SUNDRY NOTICES AND REPORTS ON WELLS

CROSBY DEEP #4

Proposed P&A – 2/6/14

Notice of Intent (NOI) to Plug and Abandon, Changes to NOI:

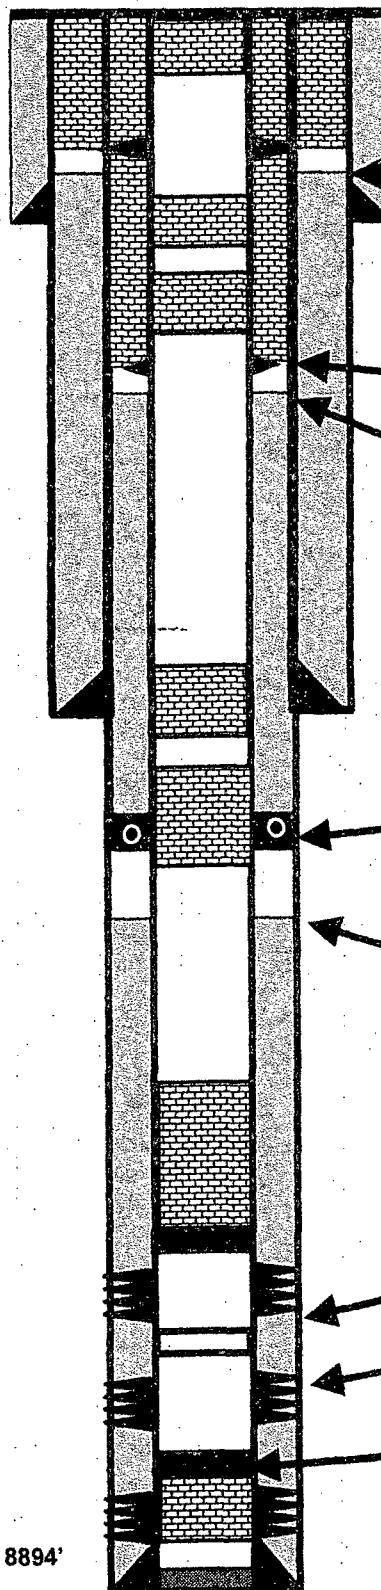
Plug No. 1, No change

Plug No. 2, 150' plug, Perforate @ 5105', squeeze cement to 4955 (covers top of Glorieta). WOC tag.

Plug No. 3, 227' plug, Spot plug from 3777'-3550' (covers shoe and top of San Andres). WOC tag.

Plug No. 4, 178' plug, Perforate @ 2290', squeeze cement to 2112' (covers base of salt). WOC tag.

Plug No. 5, 230' plug, Perforate @ 1050', squeeze cement to 820' (covers shoe and top of salt). WOC tag.

Plug No. 6, Omit

Plug No. 7, No change

Plug No. 8, No change
